Advisory Action Before the Filing of an Appeal Brief	Application No.	Applicant(s)
	10/542,374	AKATSUKA ET AL.
Examiner	Art Unit	
Thanh K. Truong	3721

THE REPLY FILED 26 July 2007 FAILS TO PLACE THIS APPLICATION IN CONDITION FOR ALLOWANCE.

Fig. 4

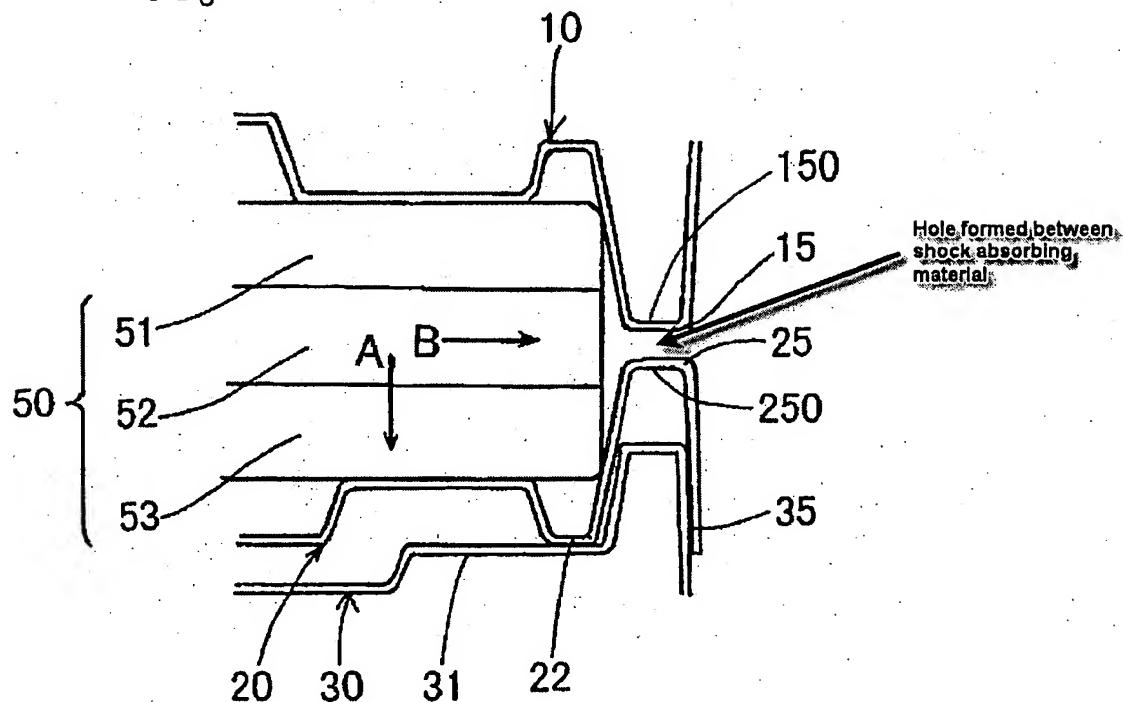
Accordingly, the examiner maintains that figures 1-8 of Koike clearly show that holes are formed on all sides of the shock absorbing material. For example, figure 1 shows opening spaces between projections, on all sides, of each of shock absorbing materials (10, 20, 30), figure 2A and 2B show the hollowed places between projections (25, 35) on all sides of each of shock absorbing materials (20, 30). Moreover, figures 4, 6 and 8 show that when the shock absorbing materials (10, 20 30) are stacking with the article (50) in between them, holes are formed between the article being packed and the shock absorbing materials.

Figure 4 provides a clear example of the forming of the hole between shock absorbing material.
